Work Order ID 133335

Item Name: Quick Release Heli-Utility-Basket™ Long, Light Lid, Spacepod™/Squirrel Cheek Comp

DART SERVICE INSTRUCTION

TO AMEND INSTALLATION INSTRUCTIONS D350-607-3 Rev.D,
INSTALLATION INSTRUCTIONS D350-607-4 Rev. C AND
INSTRUCTIONS FOR CONTINUED AIRWORTHINESS ICA-D350-607 REV. 6

FIGURE 1: INSTALLATION OF D4775-041 FWD STRUT

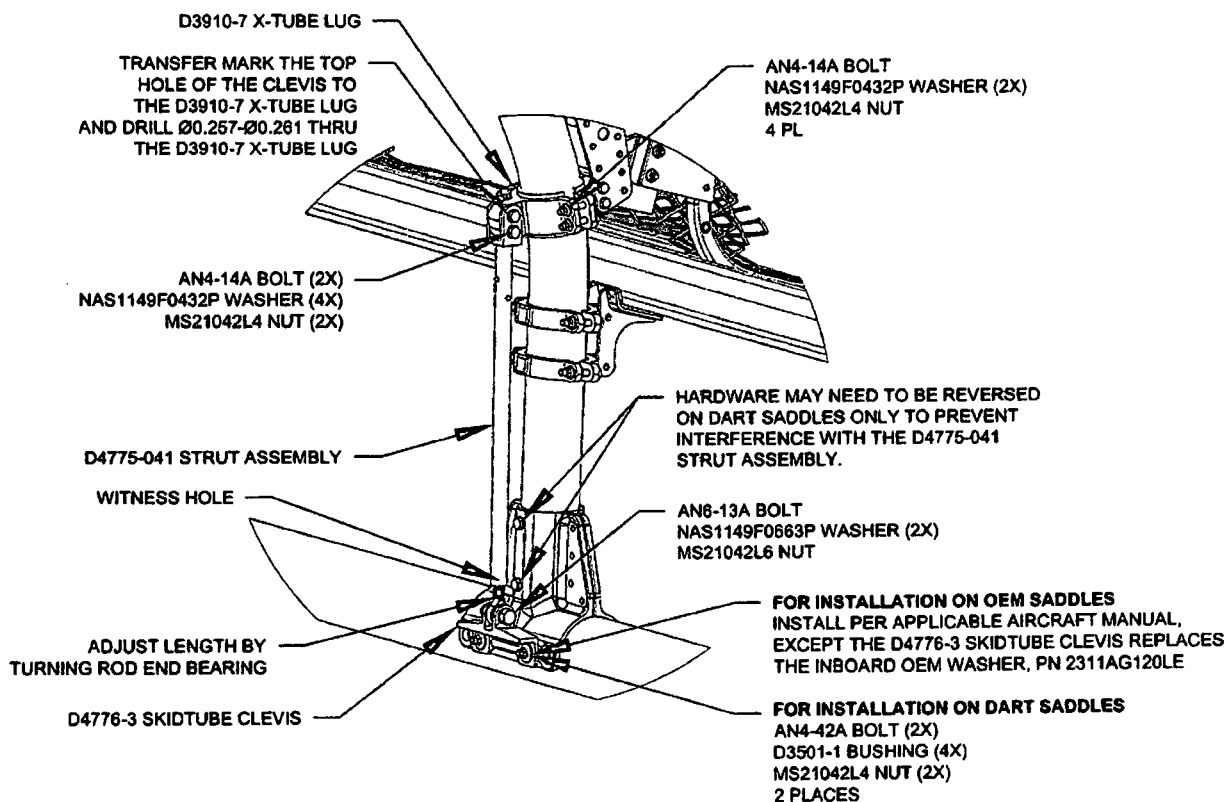
Modify the quantities for D3910-5 and add D3910-7 as follows:

- 3.1 Substitute the Forward Lower D3910-5 X-Tube Lug with the D3910-7 X-Tube Lug as shown in Figure 1.
- 3.2 Install the forward D4775-041 Strut Assembly. Transfer mark from the upper hole on the clevis of the D4775-041 Strut Assembly to the D3910-7 X-tube Lug and drill thru the lug $\varnothing 0.257$ - $\varnothing 0.261$ as shown in Figure 1. Touch up chemical conversion coating per MIL-DTL-5541. Check the witness holes located at the bottom end of the D4775-041 Strut Assemblies to ensure that the thread from the rod end extends past the witness hole.
Torque MS21042L4/-4 nuts to 50-70 in-lbs (5.7-7.9 N-m). Torque MS21042L6/-6 nuts to 160-190 in-lbs (18.1-21.5 N-m).
- 3.3 Complete the installation in accordance with Installation Instructions D350-607-3 Rev. D or D350-607-4 Rev. C.
